TITLE WOG Upper Shelf Energy CPL Reevaluation					PAGE 1 OF 1	
PROJECT WOG	AUTHOR <i>[Signature]</i>	DATE 12/14/93	CHK'D BY N/A	DATE	VERIFIED BY <i>[Signature]</i>	DATE 12/14/93
S.O. MUHP-5080	CALC. NO. SMT-008/93	FILE NO. WOG-949(5080)		GROUP MEM-SMT

The purpose of this analysis is to revise the information pertaining to the H.B. Robinson Plant (Plant 7) in Table 3-2 of WCAP-13587, Rev 1 (Reference 1) to incorporate the following:

**CAROLINA POWER & LIGHT COMPANY
H. B. ROBINSON UNIT 2
Reactor Vessel Upper Shelf Energy Re-Evaluation**

H. B. Robinson Upper Shelf Energy Re-Evaluation

DEFINITION OF ASME AND ASTM ORIENTATIONS

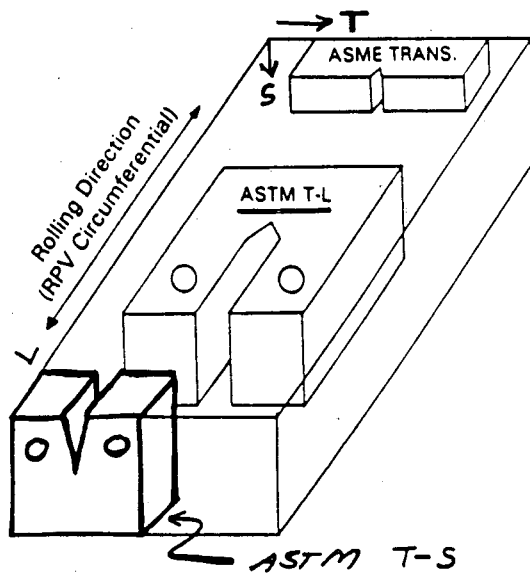
1. The initial average charpy value assumed in Reference 1 for the material of Reference 2 was 50 ft-lbs. J_{material} is modified to reflect the actual initial value of 53.6 ft-lbs.
2. Reference 3 contains a relationship to adjust the J_{material} value of the Reference 2 ASTM A 302B plate material for different temperature values. The technique described in Reference 1 along with this temperature correction is used to calculate J_{material} for this plant.
3. Table 3-2 of Reference 1 conservatively utilizes J_{applied} for a flaw which is axially orientated with J_{material} values for the transverse direction. J_{material} is recalculated for both the transverse and longitudinal direction, and J_{applied} for circumferential and axial flaws are compared with the transverse and longitudinal values, respectively as depicted in the attached figure.

Next, for comparison of the transverse orientation to circumferential flaw and longitudinal orientation to axial flaw, the J_{applied} values are given below:

It is shown that $J_{\text{applied}} < J_{\text{material}}$ and $(dJ/da)_{\text{applied}} < (dJ/da)_{\text{material}}$ in each respective direction. Note that longitudinal/axial values are supplied for information only as irradiated Charpy Energy is predicted to remain well above 50 ft-lbs in that direction.
